Date: Friday, May 28, 2021
To: Richard F. Gosselin, Jr, Chairman; Paul A. Piktelis, Vice Chairman; Terry Burke Dotson, Member; Mathew Ashmankas, Member; Bruce M. Devault, Member; and Millbury Planning Board
From: Steven S. Stearns
Reference: Public Hearing Comments (from a son of the owners and resident of **Map 62 Parcel 98**)
McLaughlin Family Living Trust; John Antaya; and Kathleen (McLaughlin) Mardirosian (the “owners”)
Whitney Street Home Builders, LLC (the “developer”)
17 Rice Road, Millbury, MA (a/k/a Rice Pond Village Project)

RE: New England Development – Lancaster Street Retail Development

Air & Noise Compliance, Inc. (ANC) is submitting this letter in response to our assessment of the present conditions, the proposed New England Development (NED) noise mitigation alternative and the permit requirements for the NED retail development on Lancaster Street (Site). The following documents were reviewed during this assessment:

Figure 1

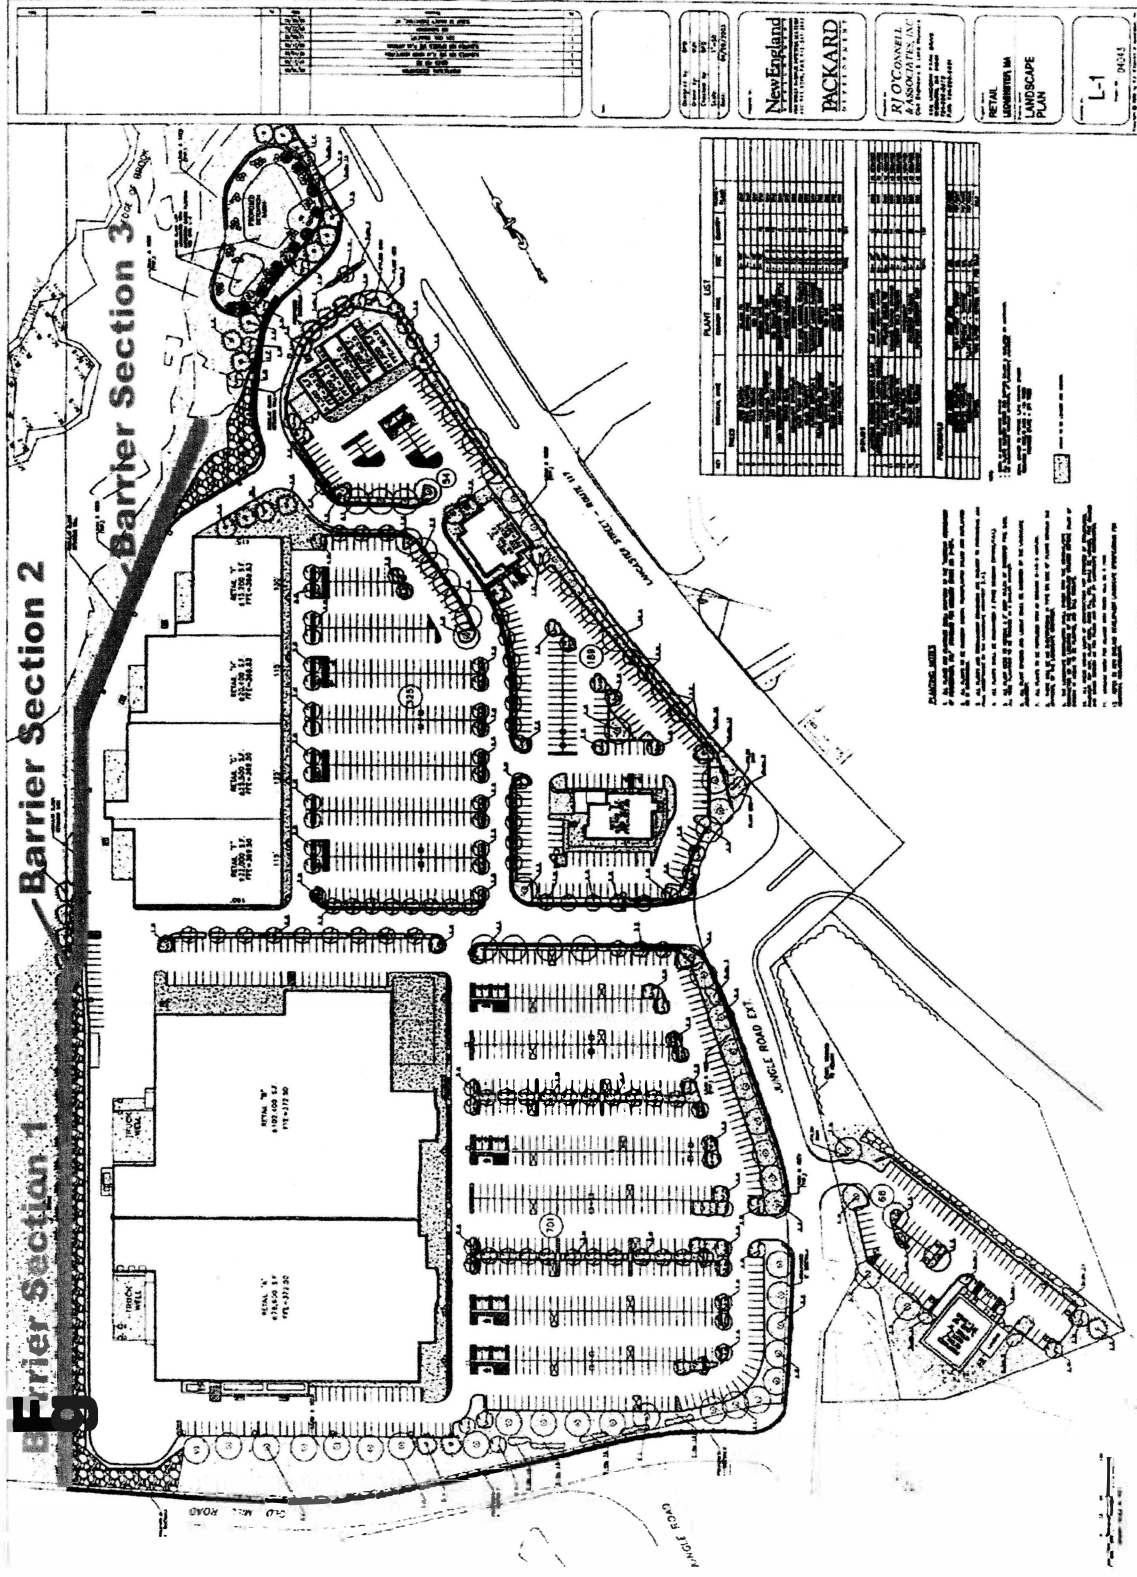
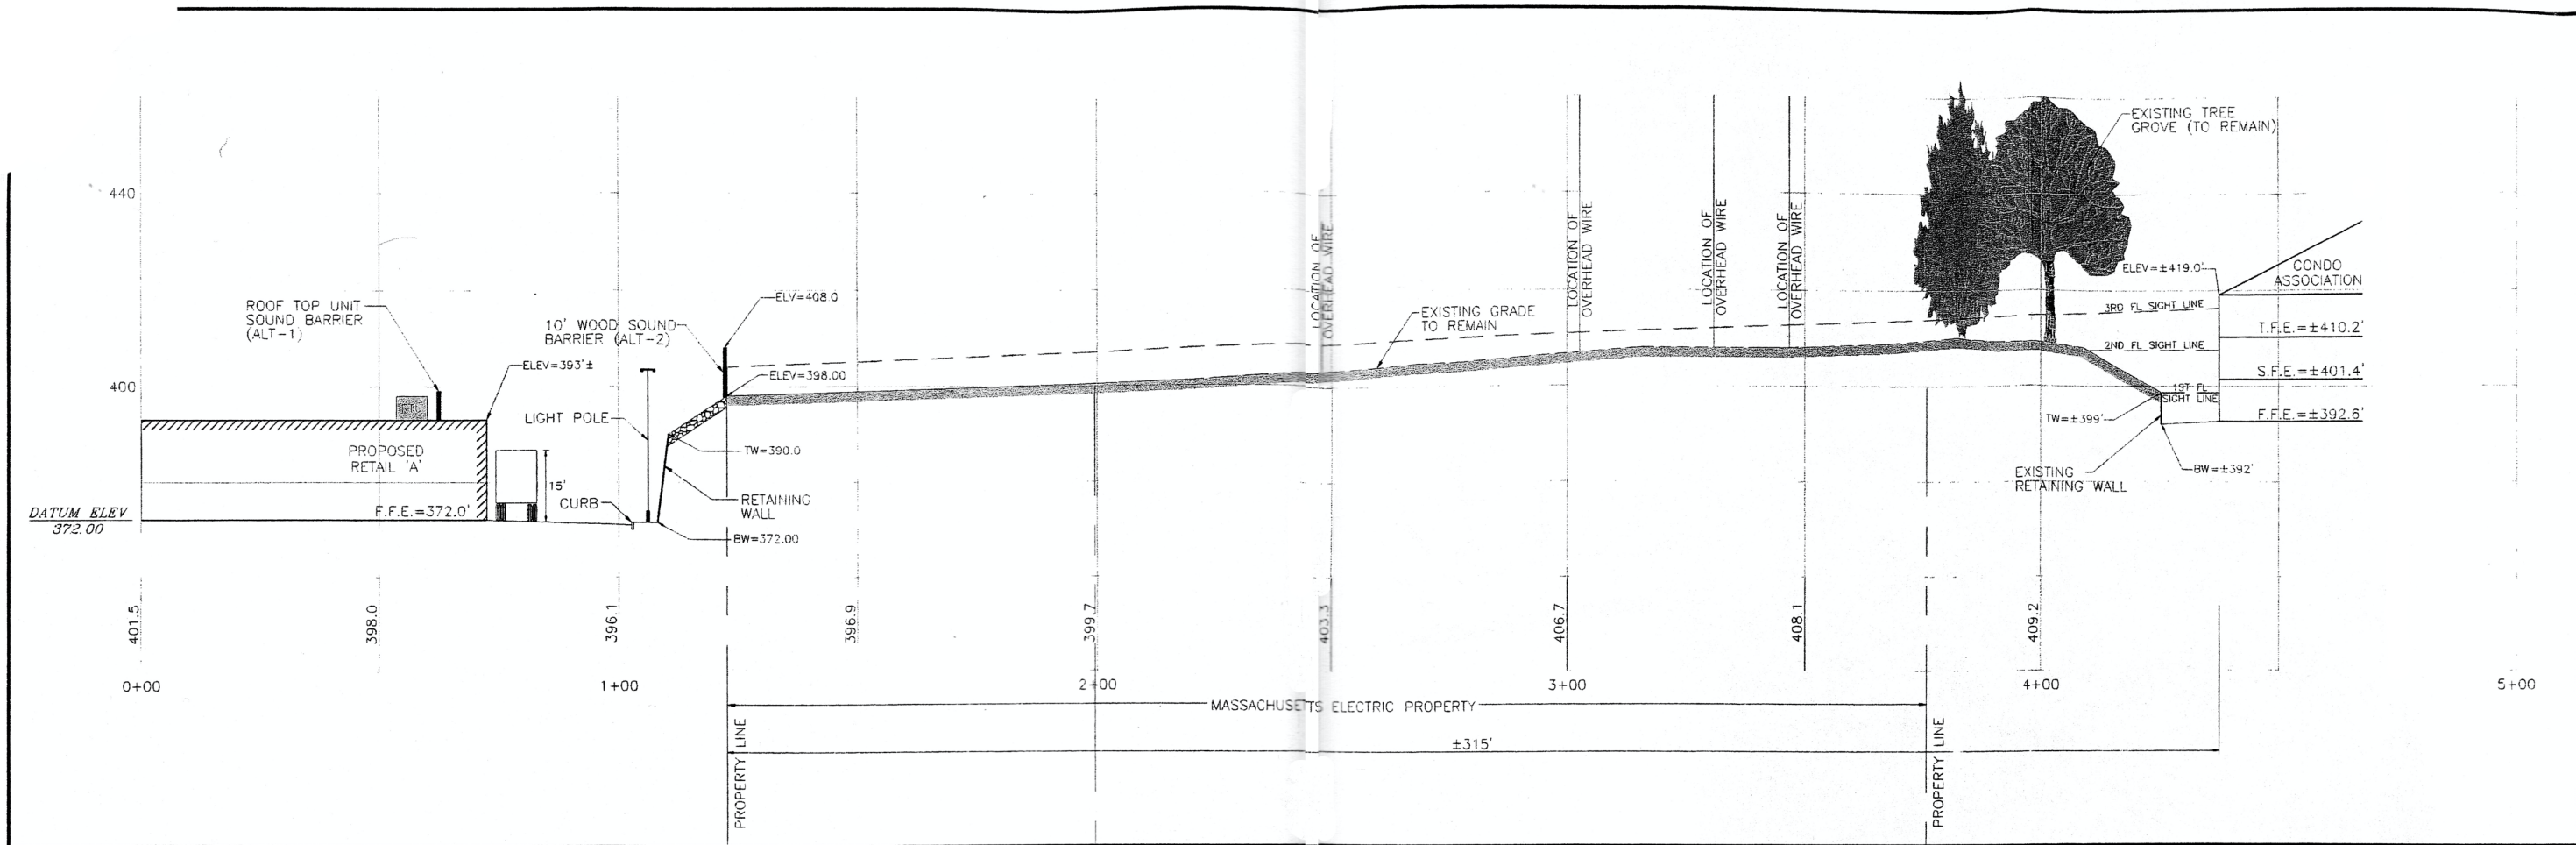
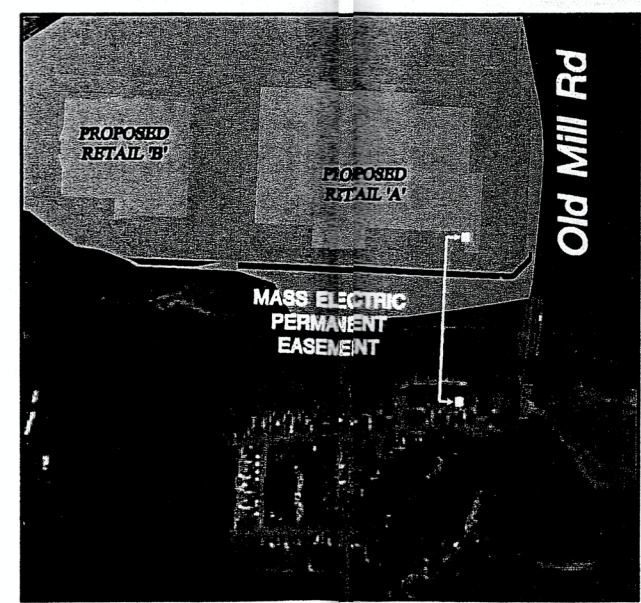
After review of the project site and the project documentation cited herein it is our opinion that the noise barrier specified in the Site Plan Review Approval be included in the NED project. ANC prepared Figure 1 to illustrate the siting of the noise barrier. The noise barrier stipulated in the Site Plan Review Approval along Old Mill Road does not need to be constructed for the benefit of the Liberty Commons development and would only be necessary for shielding any future development on the other side of the street from the NED development. The noise barrier stipulated in the Site Plan Review Approval along the property line with New England Power should be continuous (or overlap three times the distance of the gap between the break in continuity), with the key components of the noise barrier system including the following:

1. Barrier Section 1 - A noise barrier wall 12 feet high, located on or about the property line, extending from Old Mill Road to the steep decrease in elevation. This noise barrier will also help shield the Liberty Commons development from visual impacts and light intrusions associated with the retail development.
2. Barrier Section 2- A noise barrier wall 12 to 13 feet high that transitions from the elevation and property line location of the previous barrier component to the next section.
3. Barrier Section 3 - A noise barrier wall 13 feet high along the rear access/loading dock area, extending beyond both ends of that four-unit retail building.
